# 1972 F7-A

## PARTS DIAGRAM

## SWING ARM/SHOCK ABSORBERS ('71-'73 F7/F7

| Ref. No. 27, Chain Adjuster | | |

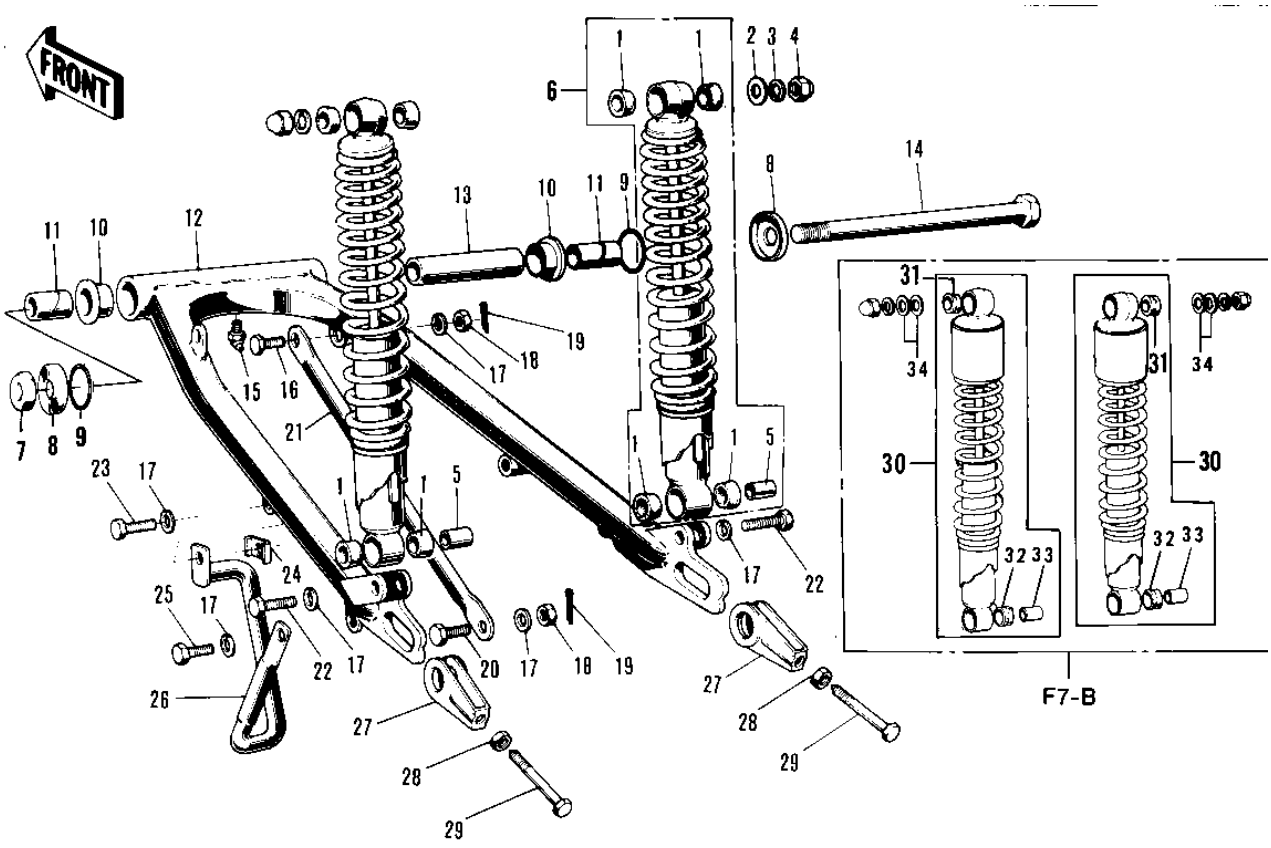
| Ref. No. 27, Chain Adjuster | | |
|---|---|---|
| | OLD | NEW |
| | 1.6 mm, 15.2 mm | 3.2 mm, 13.7 mm |
| Chain Adjuster | 33041-041 | 33041-048 |
| Collar | 42032-027 | 42032-036 |
| Frame No. | ～20779 | 20780～ |

| Ref. No. 27, Chain Adjuster | | |
|---|---|---|
| Interchange? | Use new parts **as a set** in place of old parts. | |
